SERVICE BULLETIN # 1083

MODEL 1-50, 1-60 DATE 1/22/60

SUBJECT NEW OILER PUSH ROD SEAL AND SEAL RETAINER

FIGURE 1

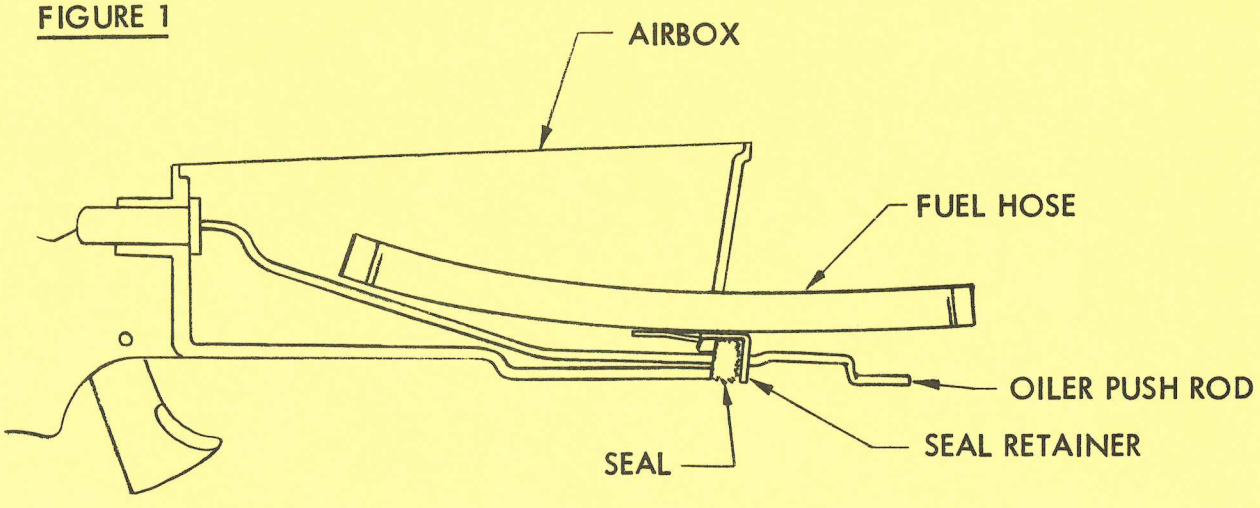
To prevent dirt and sawdust from entering the airbox through the oiler push rod hole, a new felt Oiler Push Rod Seal, P/N 55449, and a new Oiler Push Rod Seal Retainer, P/N 57061, are being installed on all Model 1-50 and 1-60 chain saw engines in production.

1. Remove air cleaner cover assembly and Tillotson carburetor from airbox.
2. Remove airbox from engine. Remove fuel hose from the airbox.
3. Install new Oiler Push Rod Seal, P/N 55449, and new Seal Retainer, P/N 57061, on oiler push rod and place Push Rod Seal tightly against oiler push rod hole.
4. Insert top of seal retainer through the fuel hose hole in airbox so that detent is inside airbox. (Figure 1.)

5. Reinstall fuel hose in airbox securing Seal Retainer.
6. Reassemble airbox on engine and reinstall Tillotson carburetor and air cleaner cover assembly on airbox.
